Technical Service Bulletin

97 Replacement fuse panel SA/SB has no power distribution bar (SA panel)

97 14 44 2037079/1 April 29, 2014.

Model(s)	Year	VIN Range	Vehicle-Specific Equipment
А3	2009	All	Not Applicable

Figure 3. 30A fuse in position SB16.

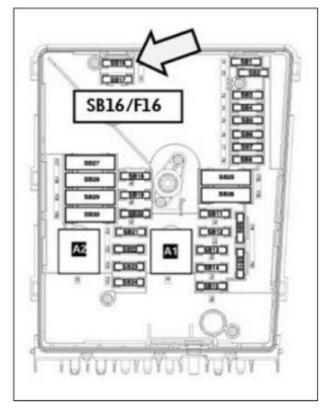
- 2. Install the power distribution bar from the original fuse panel to the new replacement SB panel.
- 3. A 30A fuse must be used in position SB16 (Figure 3) after the new fuse panel assembly is installed.
